SERVICE BULLETIN NO. 313

3479 Kodak MINILOADER 2000P

Possible Light Leak after installation of Mod 11 on the MINILOADER 2000P

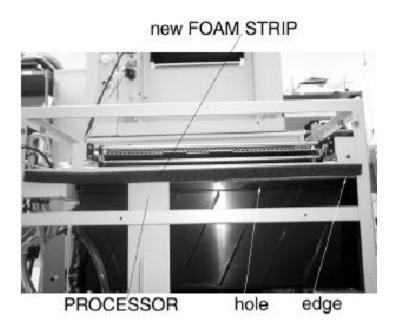
4. Remove 4 SCREWS and WASHERS holding REAR PANEL

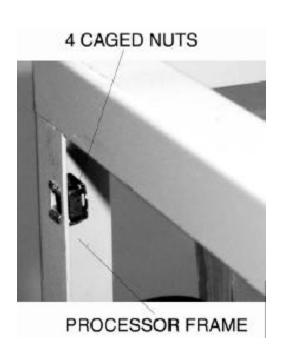
At any sites where you previously installed Modification 11 without this FOAM, you **must** add FOAM between the BACK PANEL and PROCESSOR FRAME. Even if there are no light leaks without the FOAM, changes in site light conditions in the future could create a film fogging condition, so the FOAM must be installed.

- 5. Carefully move the REAR PANEL from the PROCESSOR with the wires attached. DO NOT DAMAGE WIRES
- 6. Install a new FOAM STRIP to the PROCESSOR FRAME parallel to the edge of opening as shown. Be sure FOAM goes to both edges of the PROCESSOR FRAME.
